NEDO-10958-A  
Class I  
January 1977

**GENERAL ELECTRIC BWR THERMAL ANALYSIS BASIS (GETAB):  
DATA, CORRELATION AND DESIGN APPLICATION**

The Regulatory staff has completed its review of the General Electric Company proprietary topical report NEDE-10958, "General Electric BWR Thermal Analysis Basis (GETAB): Data, Correlation and Design Application". Enclosure 1 is the Regulatory staff's evaluation of this report.

Figure 12 LOCATION RESIDUAL VS. BOILING LENGTH FOR GEXL CORRELATION OF ATLAS DATA

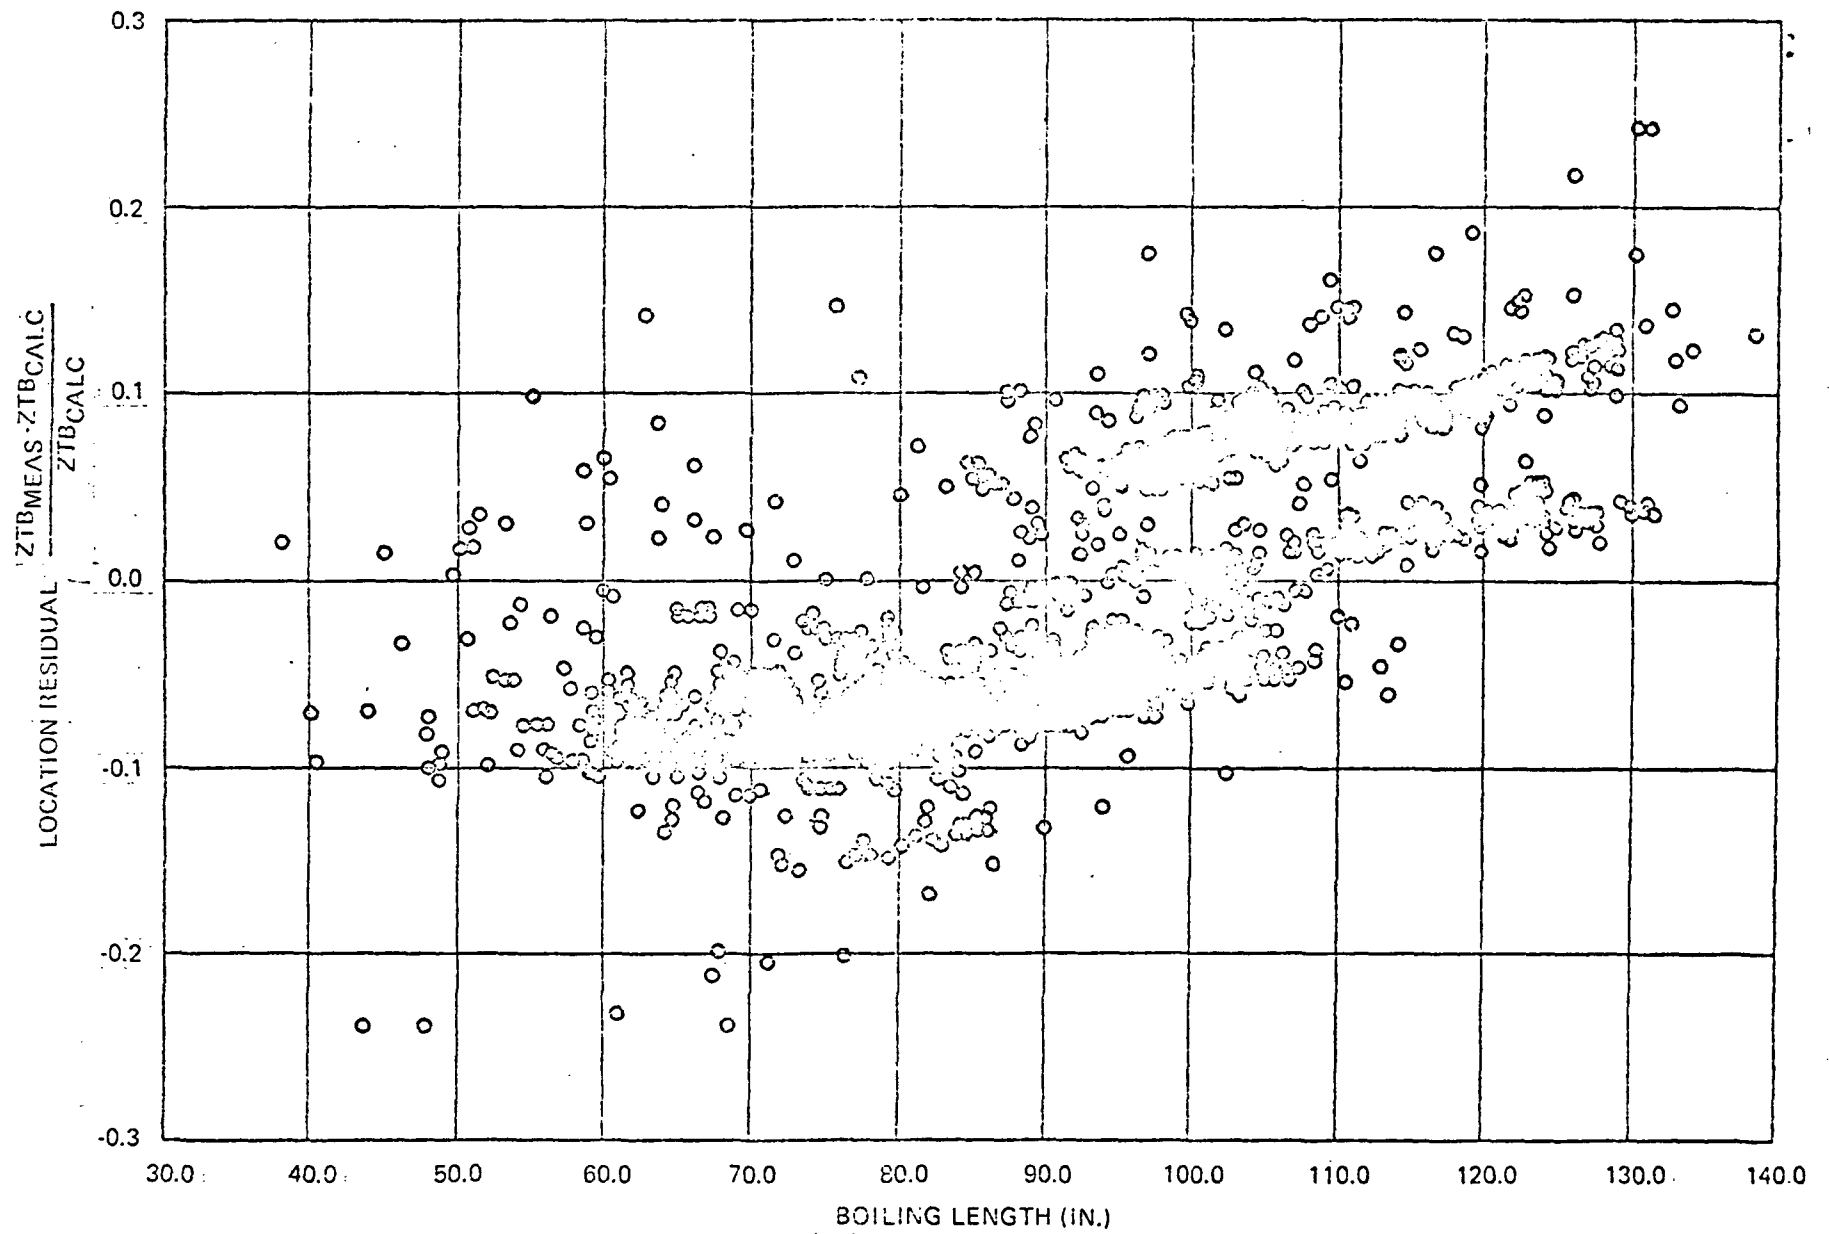
length is observed in Figure 12 where the location residual is plotted vs. boiling length. This figure shows that at shorter boiling lengths, the correlation, using the location predictor correction, generally predicts the location downstream of the measured position while, at the longer boiling length, the correlation generally predicts the location upstream of the measured position. The shorter boiling lengths are characteristic of the inlet peaked axial profile. Figure 13 shows the location residual vs. axial power shape. Generally, the scatter for the prediction of location is greater than for the prediction of power.

Figure 14 AXIAL FLUX SHAPES FOR 7 X 7 LATTICE

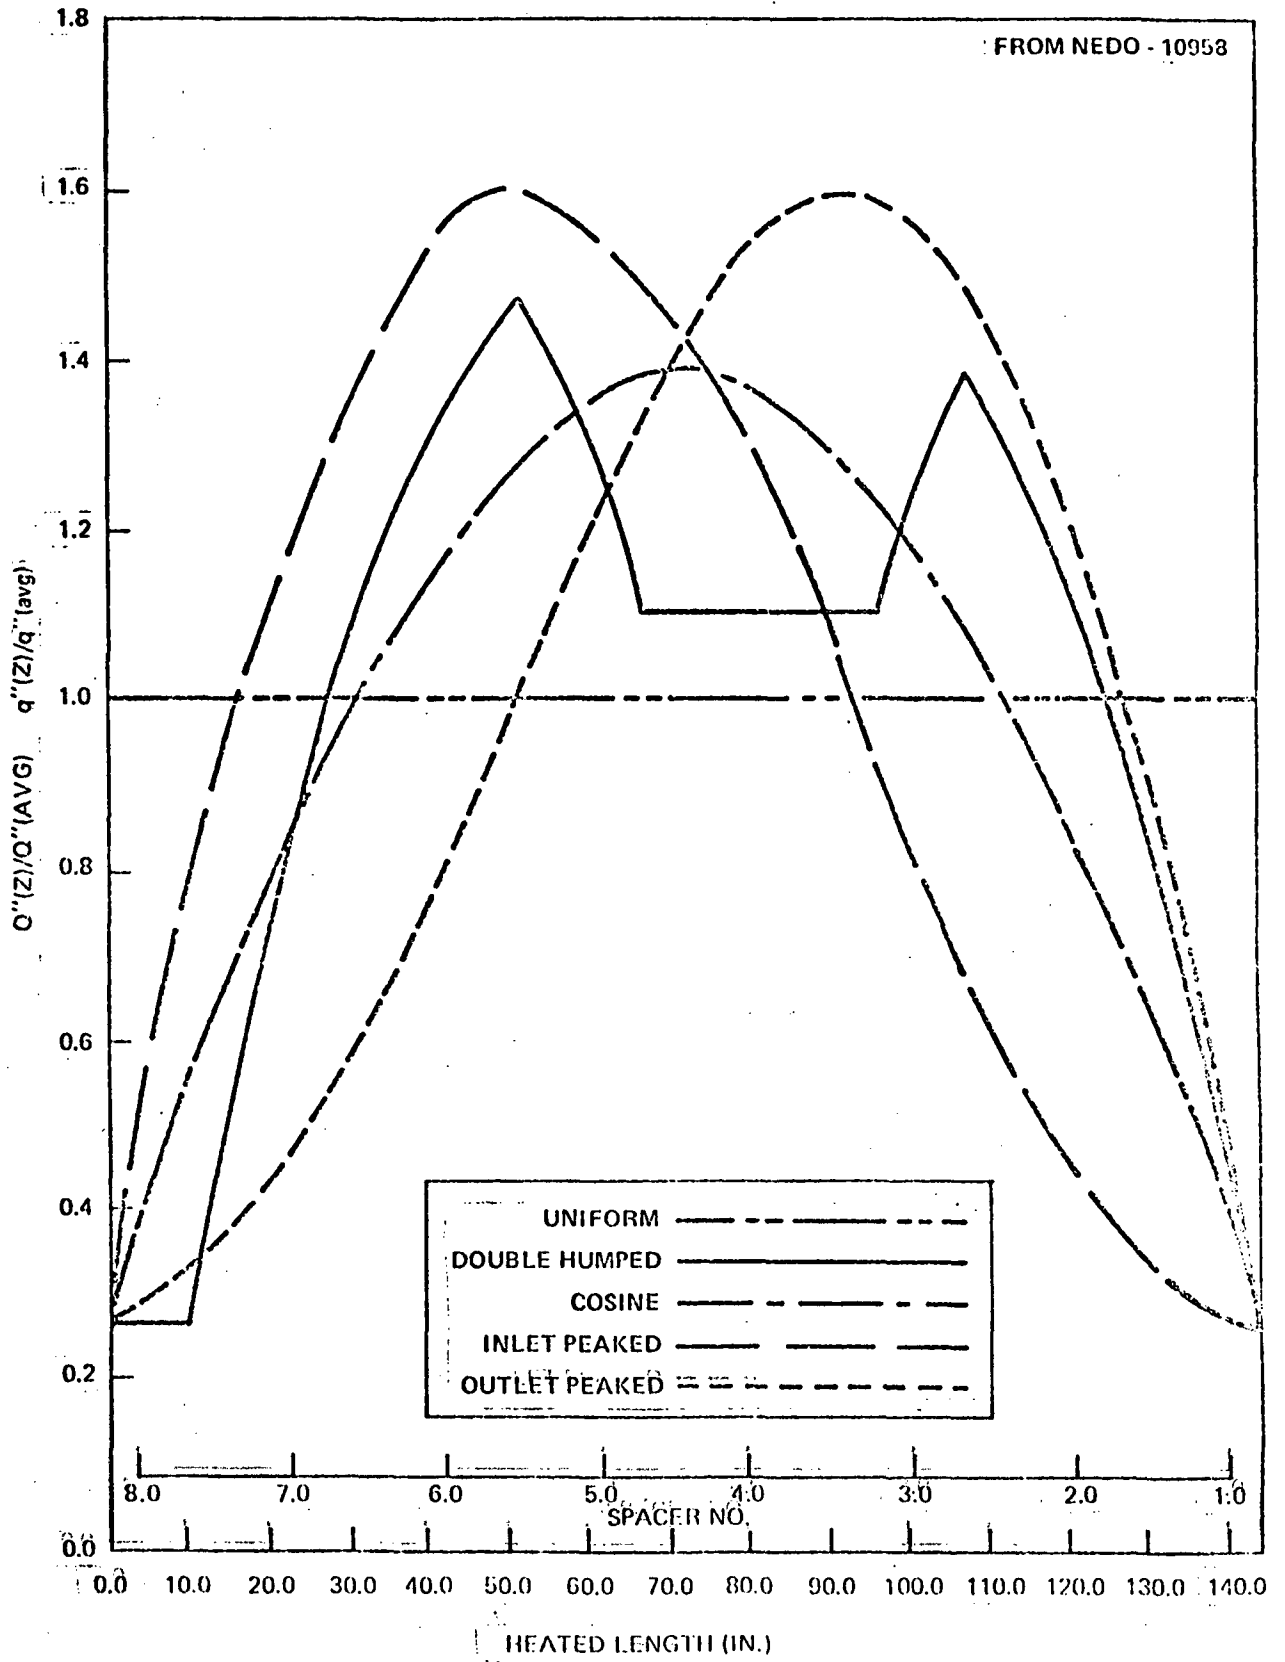
The axial flux shapes tested are those shown in Figure 14. They were chosen to represent the widest range of shapes anticipated during the core life. Considering the wide range of peaking factors included in the ATLAS program the tests appear to simulate as closely as possible the geometry and power distributions expected to occur in BWR fuel.
